Olive Downs Coking Coal Project

Additional Information to the
Environmental Impact Statement

**Responses to Submissions
Received on the Draft EIS**

**Table A1-1
Olive Downs Coking Coal Project EIS Submission Register**

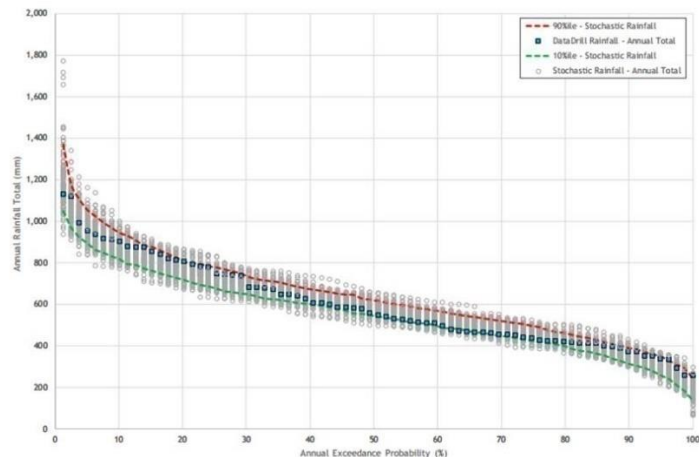
37.41		<p>Impacts</p> <p>The Department notes no additional impacts on EPBC listed threatened species and Brigalow TEC, particularly the Koala and Greater Glider, have been identified in the EIS specific to the transmission line component of the Olive Downs project.</p>	<p>Consider additional impacts on EPBC listed threatened species and Brigalow TEC, particularly the Koala and Greater Glider, specific to the transmission line component of the Olive Downs project and update the EIS accordingly.</p>	<p>Section 3.5.7 of the draft EIS provides a description of the potential impacts of the proposed ETL on threatened species, including the Koala and Greater Glider. The draft EIS conservatively assumes that the removal of all habitat for the Koala and Greater Glider within a 10 m wide corridor would be removed by the ETL.</p> <p>As outlined above, the detailed design phase of ETL is currently underway and more specific information regarding the construction of the ETL would be provided in the Plan of Operations.</p> <p>Further to this the Fauna Species Management Plan to be prepared and implemented by Pembroke would provide specific management measure to minimise the potential impacts of construction activities on threatened fauna, including specific measures for the Koala and Greater Glider.</p> <p>Notwithstanding, Pembroke considers that the works associated with the ETL would result in a significant impact to the Brigalow TEC, Koala and Greater Glider and as such is proposing to provide an offset for these species in accordance with the <i>EPBC Act Environmental Offsets Policy (2012)</i> (refer Section 10 of the Additional Information to the EIS).</p>

Issue No.	EIS Chapter / Section	Issue Detail	Submitter Recommendations / Suggested Mitigation	Pembroke Response
37.42		<p>Impact Avoidance, Mitigation Measures and/or Management Plans</p> <p>The Department notes no additional measures to avoid, mitigate and/or manage impacts on EPBC listed threatened species and Brigalow TEC, particularly the Koala and Greater Glider, have been identified in the EIS specific to the transmission line component of the Olive Downs project.</p> <p>See comment 34 above.</p>	<p>Consider additional measures to avoid, mitigate and/or manage impacts on EPBC listed threatened species and Brigalow TEC, particularly the Koala and Greater Glider, specific to the transmission line component of the Olive Downs project and update the EIS accordingly.</p> <p>Supporting evidence (e.g. published research or studies, Australian standards, etc.) which demonstrates the appropriateness and success of proposed measures must be discussed.</p> <p>See comment 34 above. The same considerations apply to the specific avoidance, mitigation and management measures for the transmission line component of the Olive Downs Project.</p>	<p>The detailed design of the ETL would implement aerial crossings over waterways (including the Isaac River) and thereby avoid clearing of riparian vegetation or instream wetlands. Detailed design is currently being conducted and additional information regarding the construction of the ETL would be provided in the Plan of Operations.</p> <p>The Fauna Species Management Plan to be prepared and implemented by Pembroke would provide specific management measure to minimise the potential impacts of construction and maintenance activities on threatened fauna, including specific measures for the Koala and Greater Glider (e.g. use of a qualified fauna spotter catcher during clearing activities). The measures would focus on minimising/mitigating impacts to these species during clearing as outlined in Section 7 of the Additional Information to the EIS. Measures would include:</p> <ul style="list-style-type: none"> Impact avoidance measures outlined in Table 7-6 of the Additional Information to the EIS (including minimising potential impacts to the riparian corridor associated with the Isaac River). Vegetation clearance procedures outlined in Table 7-6. This includes progressive vegetation clearing, demarcation of habitats proposed to be cleared, the implementation of pre-clearance surveys and the use of a qualified fauna spotter catcher. Implementation of a Weed and Pest Management Plan to monitor and control feral animals (DEE, 2018a). Bushfire prevention would be undertaken (DEE, 2018a). <p>The above measures are predicted to be effective in minimising potential adverse impacts from the Project on habitat for the MNES because they are focused on addressing the recognised threats to the matters and are consistent with the relevant threat abatement actions (e.g. avoiding additional habitat loss, minimising the risk of fire and controlling predators and herbivores) (DEE, 2018a).</p>
